INDESIT company

Model type:
LV65AWH

Commercial code:
F026626

n1045034: New top condenser.

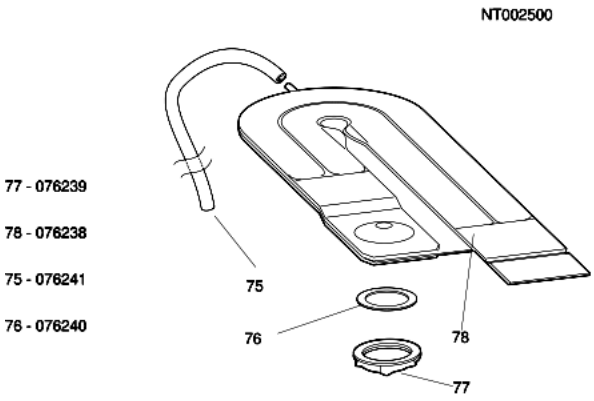
As of the last week in July 2000, the new "Wind drying system" was inserted on some appliances from the new MarckII Range. This new system foresees the elimination of the lateral air-flow body and the insertion of a new system with top condenser.
The spare part numbers eliminated are as follows:

054927(Rohs 144335) - RING NUT FOR AIR-FLOW BODY
054928 - AIR-FLOW BODY
103689 - NOZZLE GASKET
057874 - TOP SOUNDPROOFING LAYER

Whereas the new spare part numbers are:

076238 - WIND DRYNG SYSTEM CONDENSER
076239 - CONDENSER RING NUT
076240 - TOP CONDENSER GASKET
076241 - TOP CONDENSER PIPE

The new part numbers are not interchangeable with the old ones, as they are completely different. See technical drawing attached to notice NT002500.

Photo N1045062FIG1 illustrates the bottom of the dishwasher with EVO structure.

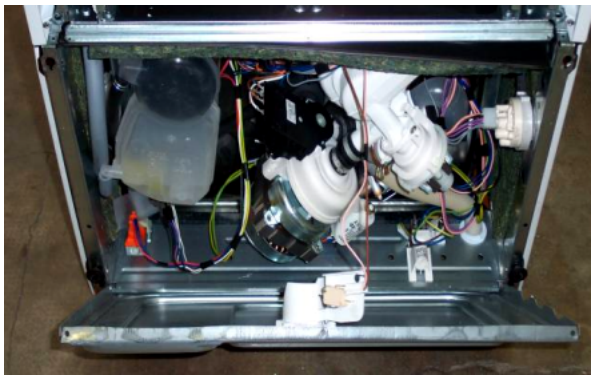
From serial number 30101.0001, all dishwasher models affected by this modification have been produced with EVO structure.
These models have been equipped with NEW TRAYS AND NEW FEET (see N1045062TAB1).

PREMODIFICATION:
Tray: 083625 (for commercial code 28490) 078809 (for commercial codes 26043-23520-28088);
Tray rear feet: 078396-078397-078385;
Tray front feet: 073972;
Front feet supports: 065836(Rohs 143584);
Feet supplied with plinth accessories assembly: 034261;

EVO STRUCTURE:
Tray: 092558 (for commercial code 28490) 092554 (for commercial code 26043-23520-28088);
Tray rear feet: 092820-092821-092822;
Tray front feet: 092555;
Front feet supports: 065836;
Feet supplied with plinth accessories assembly: 034261.

PREMODIFICATION:
Tray: 061991;
Tray feet: 073972;
Feet supplied with plinth accessories assembly: 034261;

EVO STRUCTURE:
Tray: 092554;

Tray feet: 092555;
Feet supplied with plinth accessories assembly: 034261.

Regulation assembly DX/SX Sat codes 078397 and 078396 will be managed up to stock end, after that they will be replaced by new Sat codes 092821 and092820. The same is for rear foot Sat code 078385 which will be replaced by Sat code 092822.

N1045063

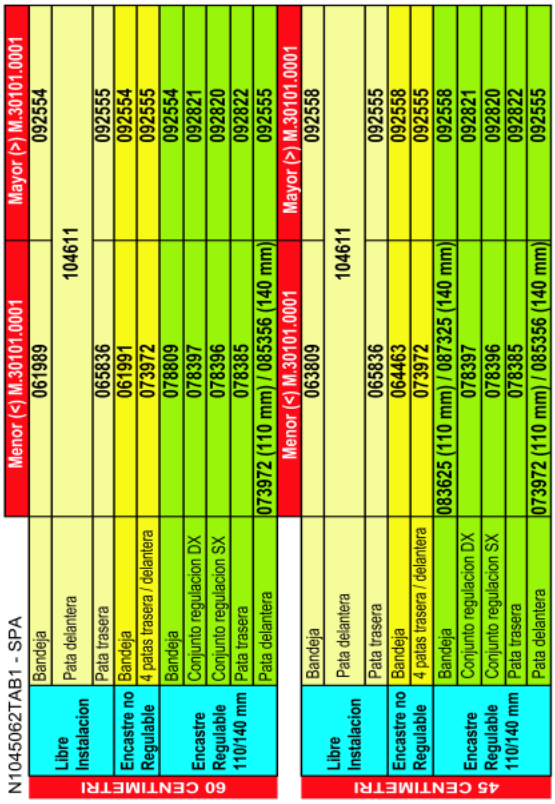
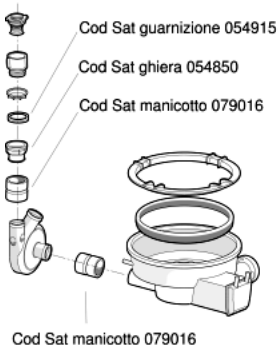
From serial number 30224.0001, all dishwashers affected by this modification have been equipped with the new coupling+ring nut assembly Sat code 093752, in place of coupling Sat code 079016, ring nut Sat code 054850 and gasket Sat code 054915.

Ring nut Sat code 054850 will continue to be available from the spare parts warehouse while stocks last, and coupling Sat code 079016 will continue to be stocked because it is still used for the tank-volute connection.
Picture N1045063 illustrates the premodification structure in FIG1 and the new structure in FIG2.

N1045081FIG1

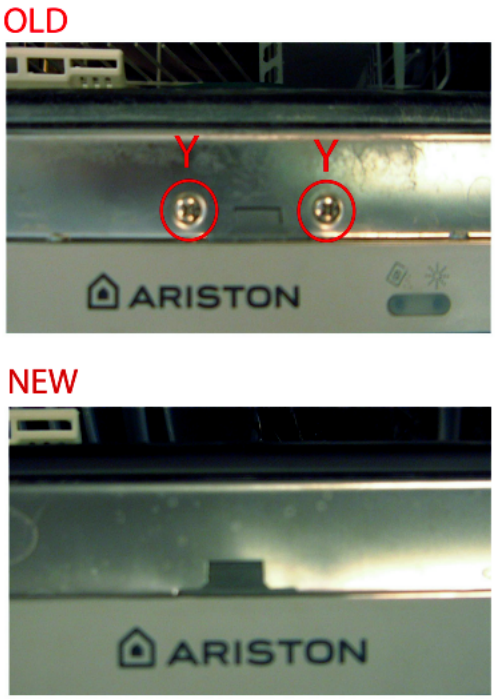
From serial no. 40614.0001, all 60 cm dishwashers affected by this note have been equipped with the locking unit code 094128 in place of 085357.
Following the elimination of the two screws Y (see N1045081FIG1) used to fix the locking unit on the inside door, the locking

unit and inside door were also modified, which can be mounted on premodification appliances by replacing the premodification locking unit with the new one.

Codes of modified inside doors:
085023 PREMODIFICATION - 112451 NEW
